# UNITED STATES PATENT AND TRADEMARK OFFICE

APPLICATION NO.	FILING DATE	FIRST NAMED INVENTOR	ATTORNEY DOCKET NO.	CONFIRMATION NO.
10/527,464	03/11/2005	Masashi Iwata	Q86804	3586
23373	7590	11/29/2005	EXAMINER	
SUGHRUE MION, PLLC 2100 PENNSYLVANIA AVENUE, N.W. SUITE 800 WASHINGTON, DC 20037			NGUYEN, PHUONGCHI T	
			ART UNIT	PAPER NUMBER
			2833

# Office Action Summary

## DETAILED ACTION

Attachment 1

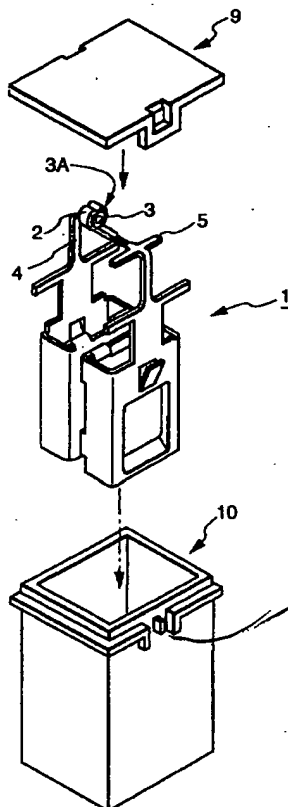
In regards to claim 1, Hanazaki et al discloses a fuse (1) comprising a fuse body (of 1); a housing (10) which is made of an insulative resin, and receives and holds the fuse body (of 1) therein, and into which the fuse body (of 1) is inserted through an upper opening (at one end of 10) in the housing (10); and a cover (9) which is made of an insulative resin, and covers the upper opening (at one end of 10) in the housing (10), wherein a retaining portion (R) is formed on a side surface of the housing (attachment 1). "Corresponding to a retaining claw of a

withdrawing jig for withdrawing the housing is formed on a side surface of the housing” is not positively recited in the claim.

In regards to claims 3 and 4, Hanazaki et al discloses the fuse wherein a pair of the retaining portions (R, R) (on both sides of 10) are provided on opposite side faces of the housing (10) so that the retaining portions (R, R) are aligned in an extending direction of a fusible portion (body of 1)/terminal portions (body of 1) of the fuse body (of 1).
